Request for Class II Permissive Change

FCC ID: VG8XM262AYY

Please be notified that we, the undersigned, **Guangdong Midea Kitchen Appliances Manufacturing Co.,Ltd.** declare that the reasons for this class II permissive change are as below:

Original Mother board-top view

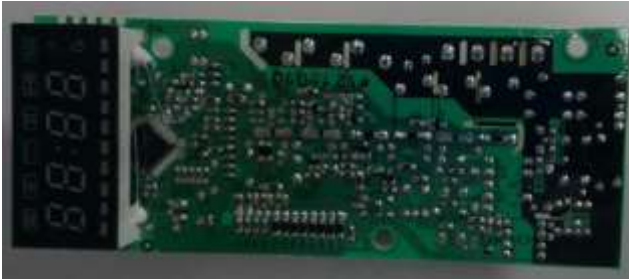
1. Changed Mother board as below.

1.New mother board has the same input/output power and similar electric specification with original. The “similar” means that input and output power is the same but some electronic components(such as relay etc)and PCB Layout differences as before.
